### APPEAL SUMMARY

| <b>Appeal ID:</b> 27621                                                                                         | <b>Project Address:</b> 1006 SE Grand Ave                                                                |
| <b>Building/Business Name:</b> The Josephine                                                                    | <b>Fire Sprinklers:</b> Yes - full NFPA 13                                                               |
| <b>Appeal Involves:</b> Erection of a new structure                                                             | <b>LUR or Permit Application No.:</b> 21-084902-CO                                                       |

LEVEL 1 MECHANICAL FLOOR PLAN  
SCALE: 1/8" = 1'-0"

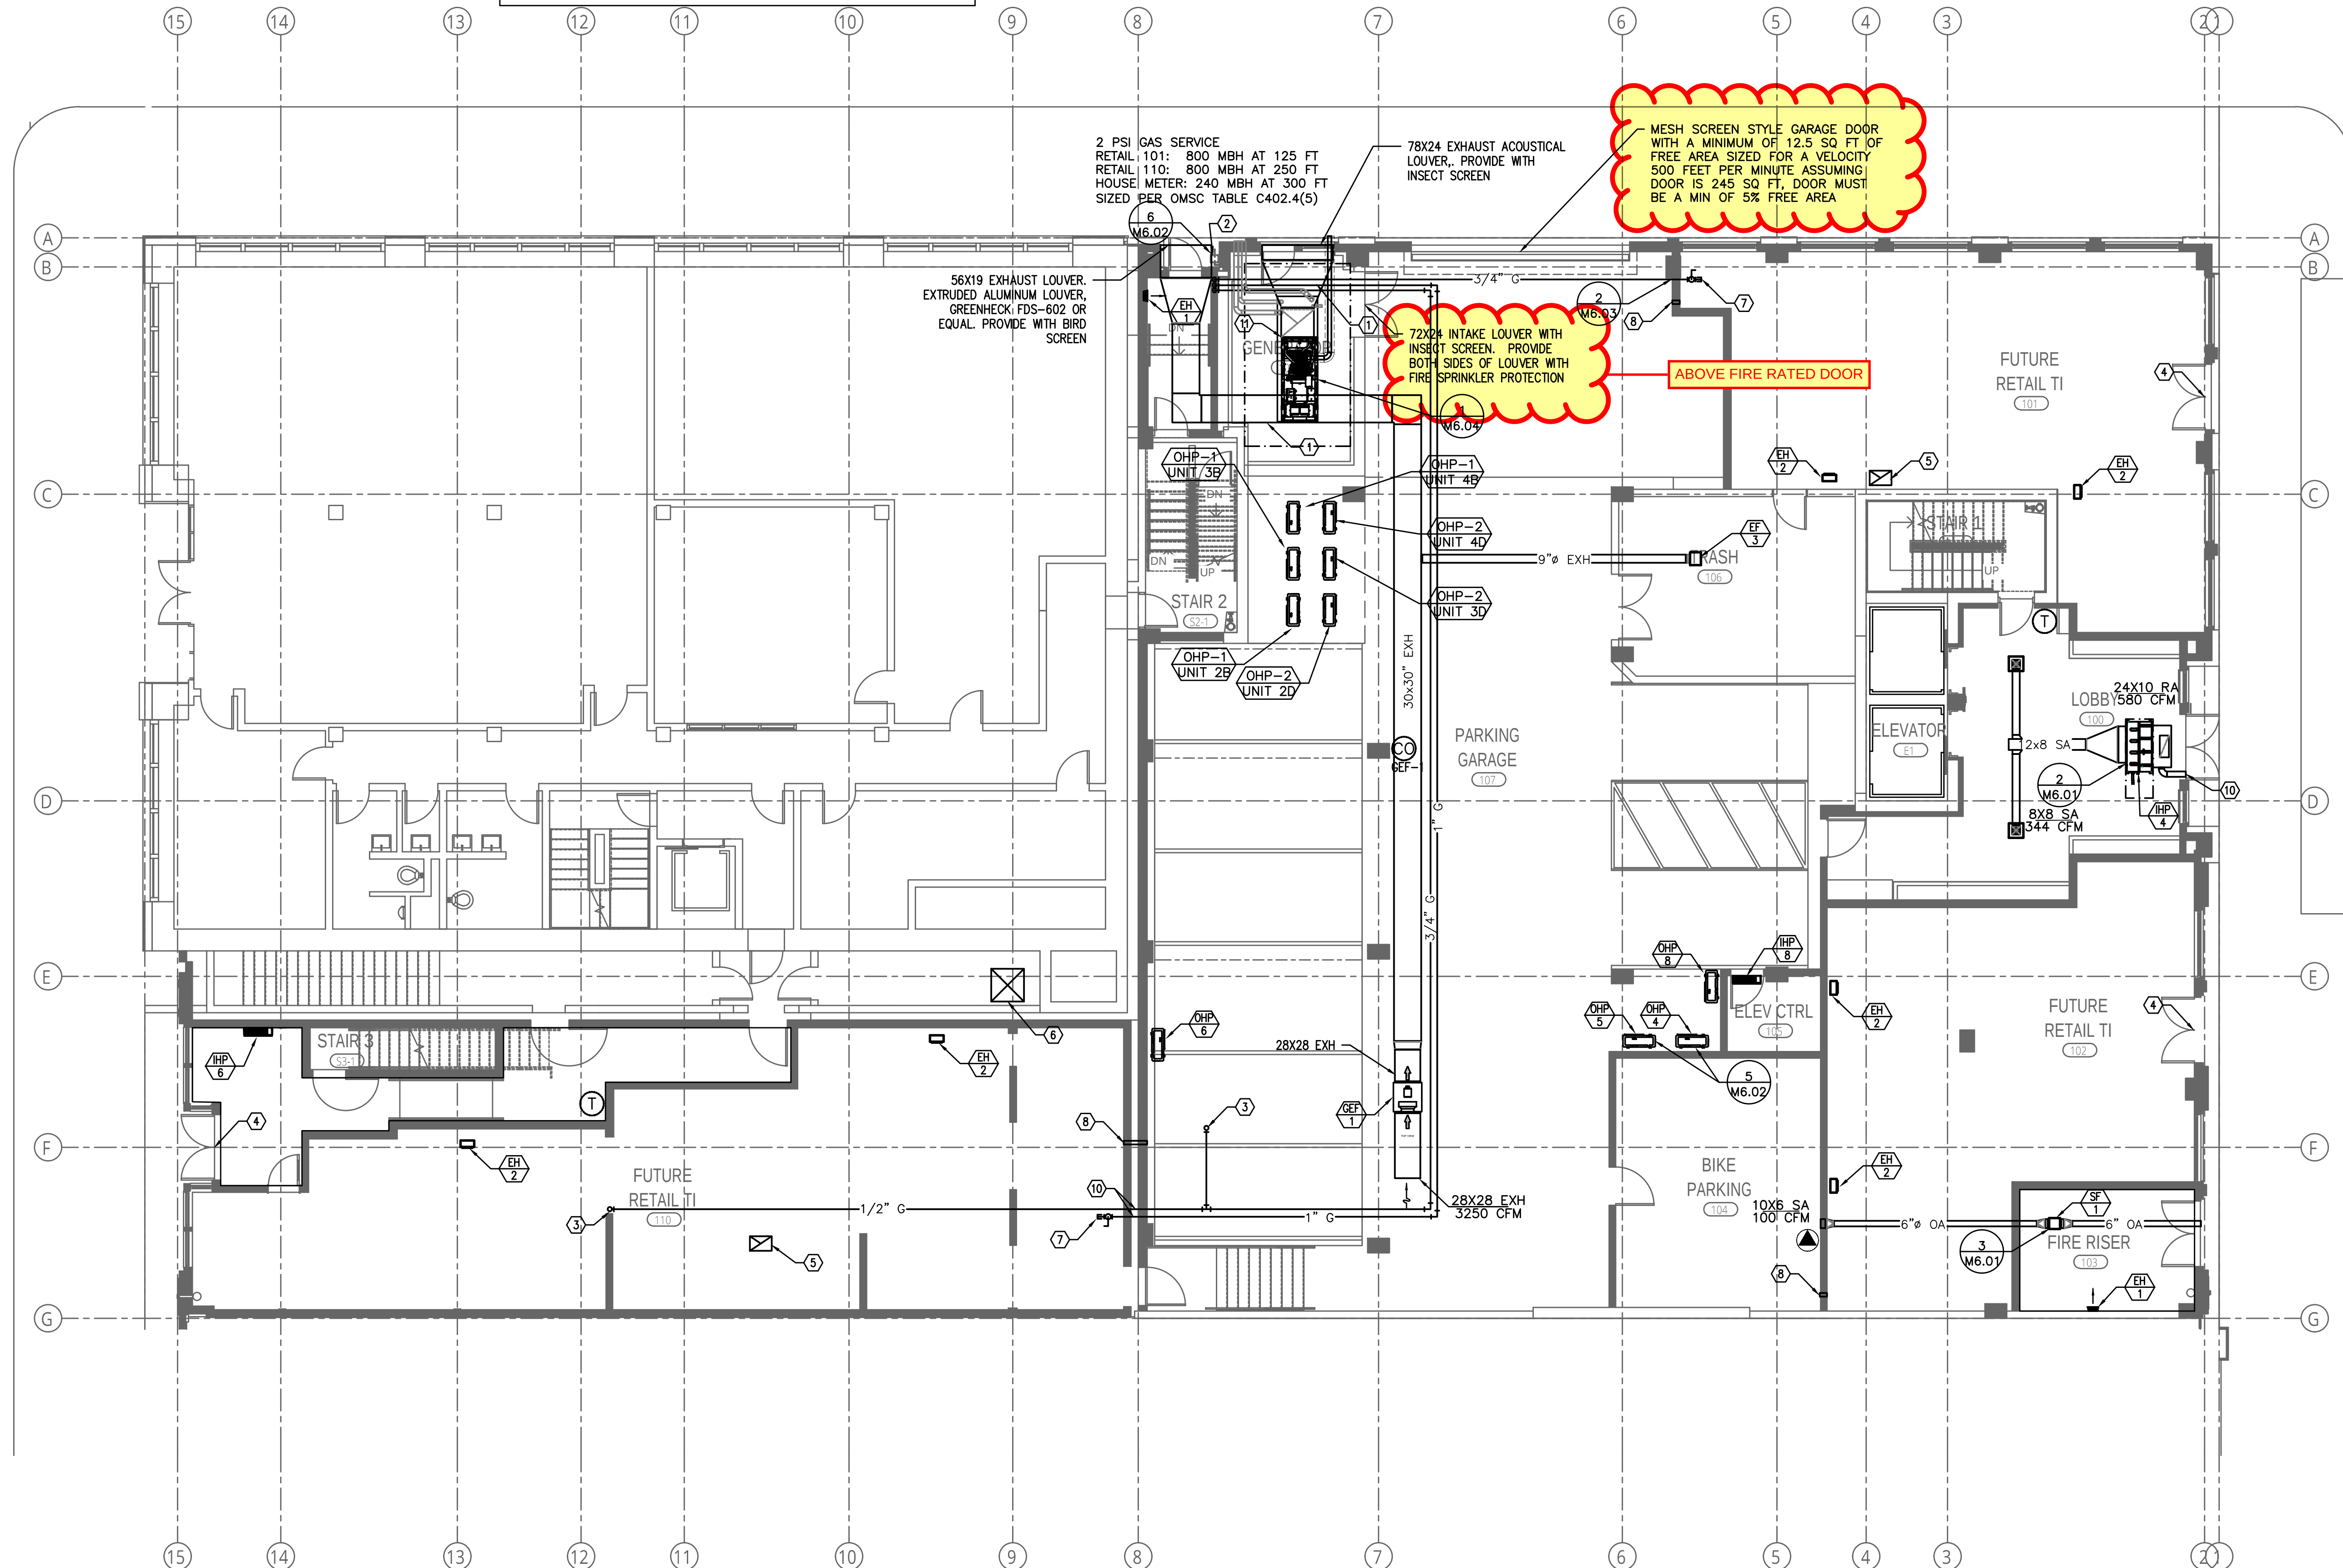
| <b>Code Modification or Alternate Requested</b> | Alternate requested is to provide increased fire sprinkler coverage at both sides of the louvered opening from the garage in lieu of a fire damper in the penetration of the 2 hour fire barrier between the garage and generator room.                                                                                                                                                                                                                                                                                                                                                                                                                                                                                                                                                                                                                                           |
| <b>Proposed Design</b>                          | <p>The proposed design meets the requirements of the NFPA 110 and Code Guide IBC/27#1 and NEC/7#1 except the air intake opening is open to the parking garage.</p> <p>Generator intake will be pulled from the Parking Garage through a perforated garage door. Generator air intake louver is protected by NFPA 13 sprinklers on both sides. The open area of the generator air intake louver is 72" x 24". The open area provided within the parking garage to the exterior (via the perforated garage door) is a minimum of 12.5 sf free area sized for a velocity 500 feet per minute. Door must be a minimum of 5% free area. Items that are not part of the generator equipment have been separated from the room by 2 hour fire rated wall.</p> <p>Wall mounted signage will be provided at the intake louver stating "Do Not Block Louver. Generator Cooling Intake."</p> |
| <b>Reason for alternative</b>                   | <p>Reference previously approved appeals 23880, 24789, 26134, 26368.</p> <p>The limited amount of exterior wall space, both practically and as directed by Portland Historic Landmarks Commission (LU 21-104162 HR), does not allow enough room for both the intake and the exhaust louvers to be positioned according to code; the proposed design capitalizes on the</p>                                                                                                                                                                                                                                                                                                                                                                                                                                                                                                        |

abundant amount of fresh air in the garage provided both mechanically and by the adjacent perforated garage door. The Historic Landmarks Commission has mandated that we provide active program functions along Yamhill Street to enhance the pedestrian experience.

**1a. Emergency generator with omission of fire damper in penetration of 2 hour fire barrier: Hold for additional information.**

**1b. Emergency generator intake air from within parking garage: Hold for additional information.**
